### Village of Summit Plan Commission Thursday, November 20, 2025, 5:30 p.m. At the Summit Village Hall, 37100 Delafield Road

**Bryant & Emma Nelson – Special Exception  
Vertical Addition to Residence within Offset  
34845 Elm Street (SUMT0670049)  
11/20/2025 Plan Commission Meeting**

**White Stone Community Church**  
**2517 N. Dousman Road (SUMT0637999008)**  
11/20/2025 Plan Commission Meeting

**LOEPFE CERTIFIED SURVEY MAP REVIEW**  
**11/20/2025 Plan Commission Meeting**  
**Lola and Bob Loepfe**

LANDSCAPING PLAN

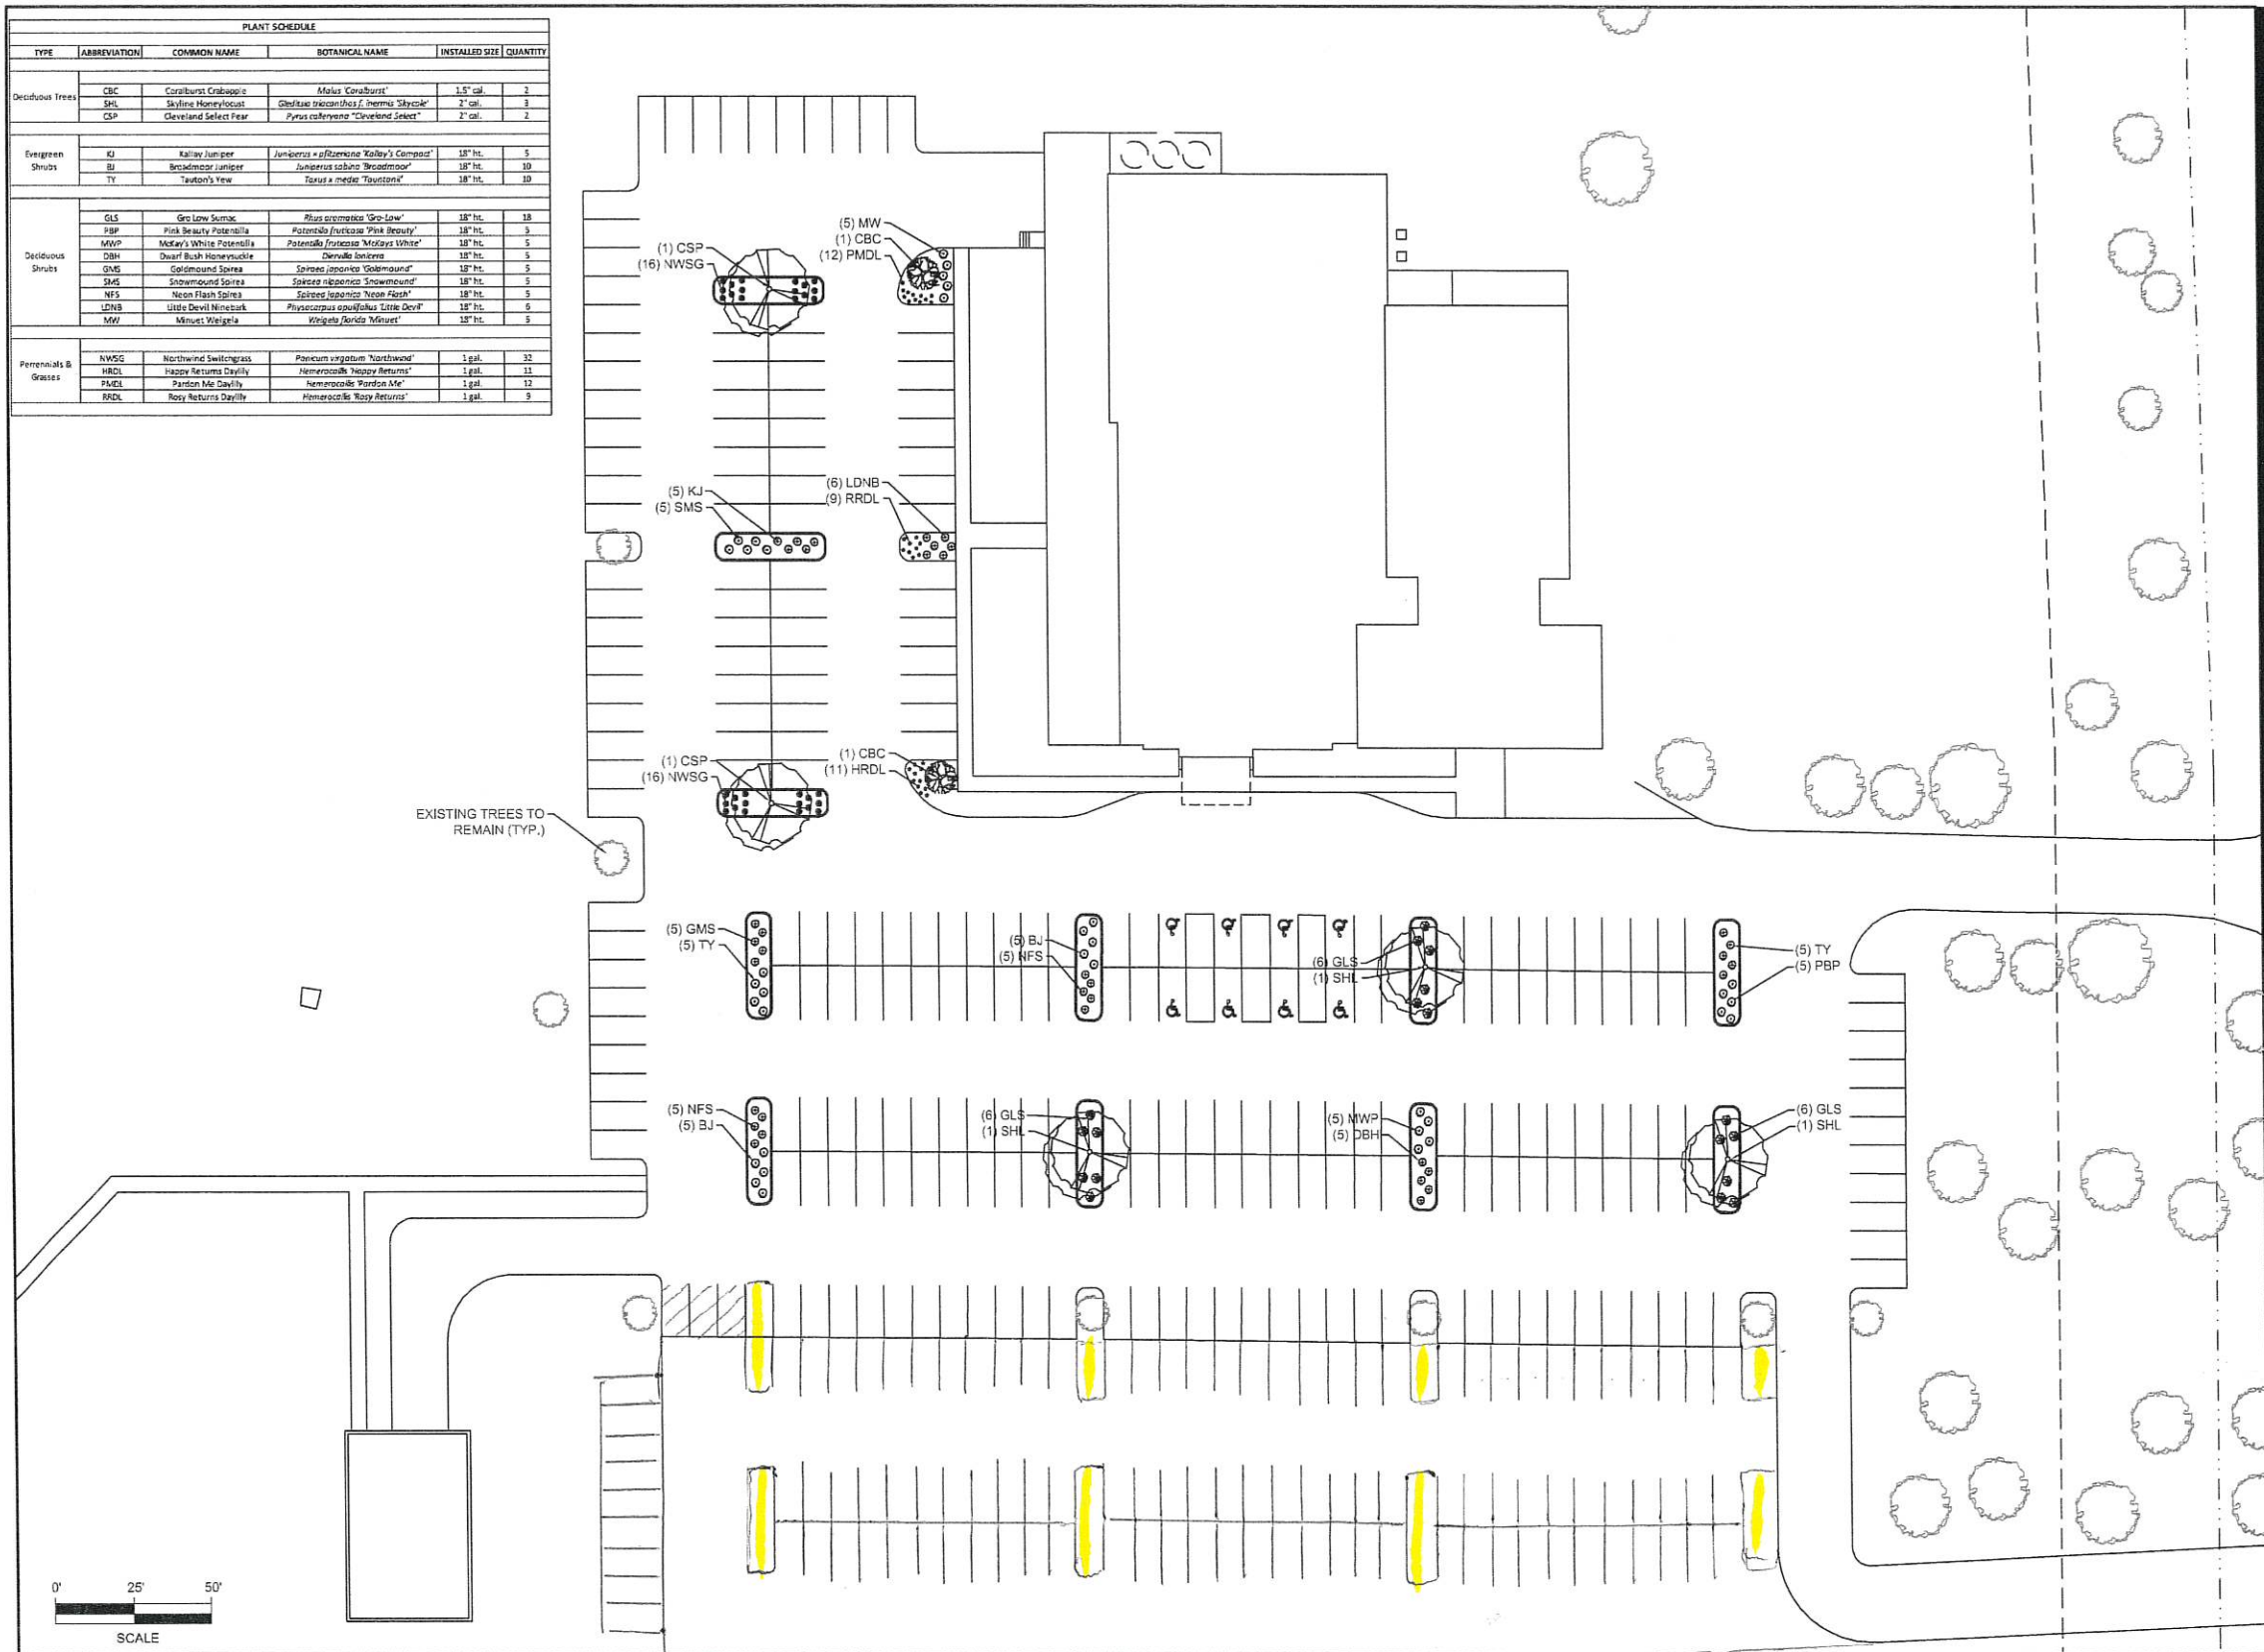
Several trees will be removed to accommodate the parking lot. A landscape plan was provided. However, the plan does not match the layout of the civil plans. The landscape plan shall accurately show the parking area as it relates to the lot lines and civil plans. The applicant is proposing plantings in the proposed landscape islands. Landscaped areas shall occur every 15 spaces and shall divide areas with more than two aisles of parking. Each landscape area shall measure not less than 75 sq. ft. It appears that a landscape island will be required to break up the parking on the east side of the parking lot. Accessory landscaped areas shall make up at least 5% of the surfaced parking area. The applicant will need to demonstrate that these requirements have been met. At least 10 ft. of greenspace shall be provided between the lot line and parking area. There is at least 10 ft. of greenspace available.

2517 N. Dousman Road (Light scene 1)

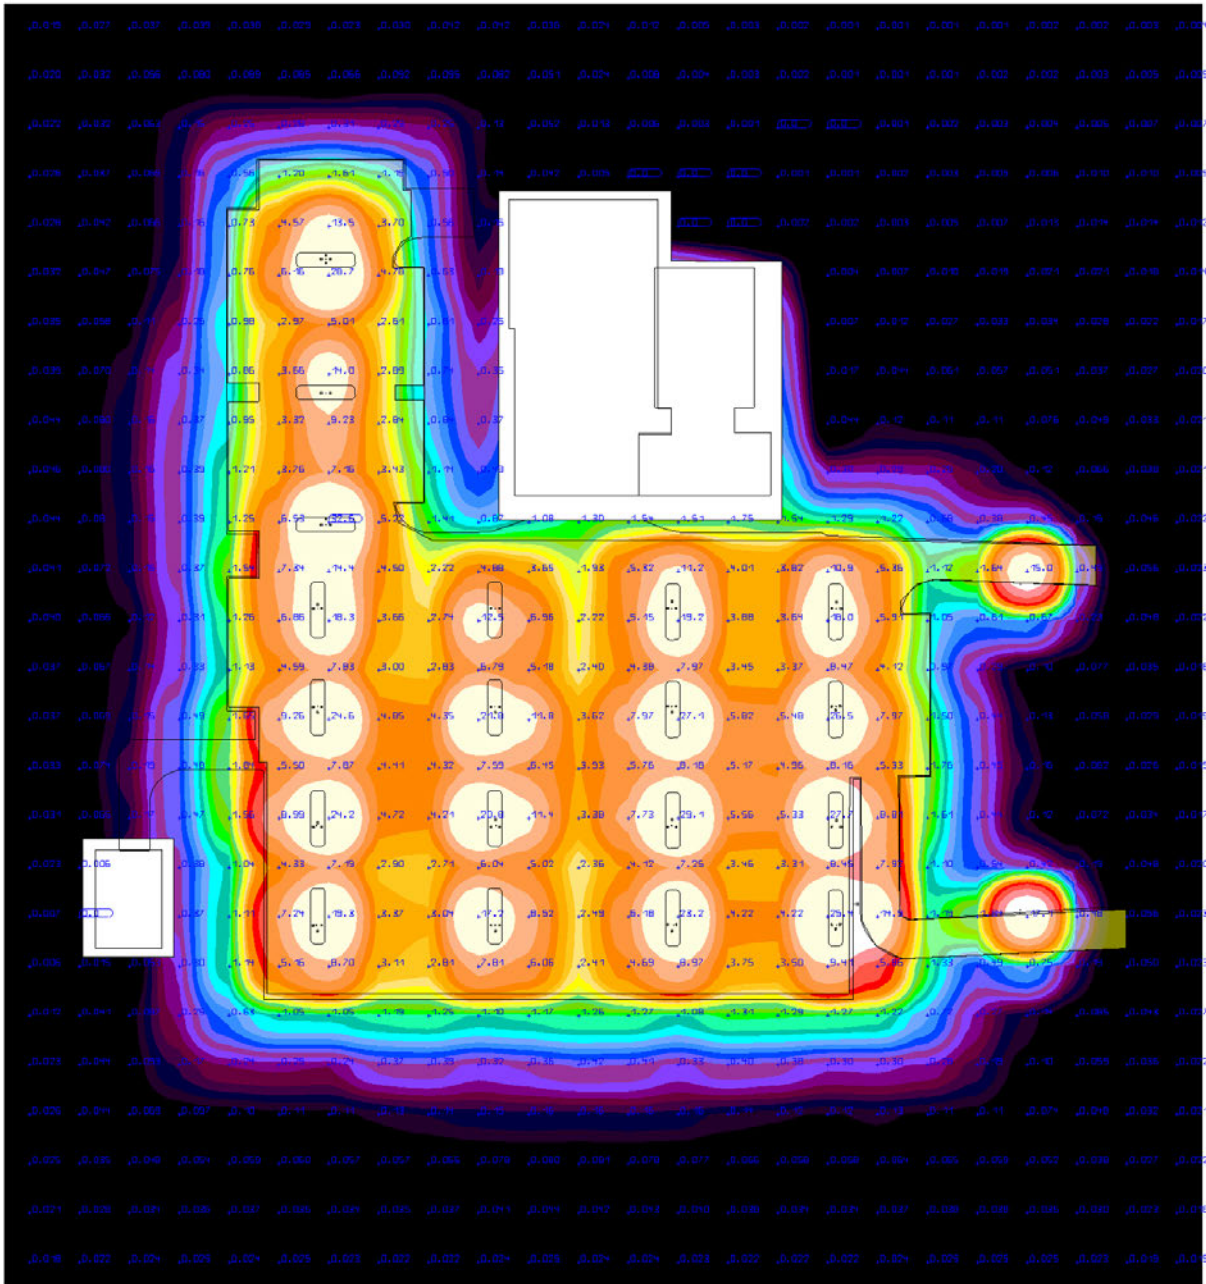
The applicant is proposing to install additional pole lights to accommodate the parking lot addition. It is unclear how many new pole lights are existing vs. proposed. There will be one pole light in each landscape island and at the southern entrance to the parking lot. The poles will be 15 ft. in height with an additional 3 ft. base. The lights will match the height and style of the existing lights on the property. The applicant submitted photometrics and catalog cut sheets that are included in the packet. The applicant should include the light pole locations on a site plan included in the civil plan set packet. Staff needs to review the amount of light trespass on the south and west lot lines and the lot lines are not shown on the photometric.
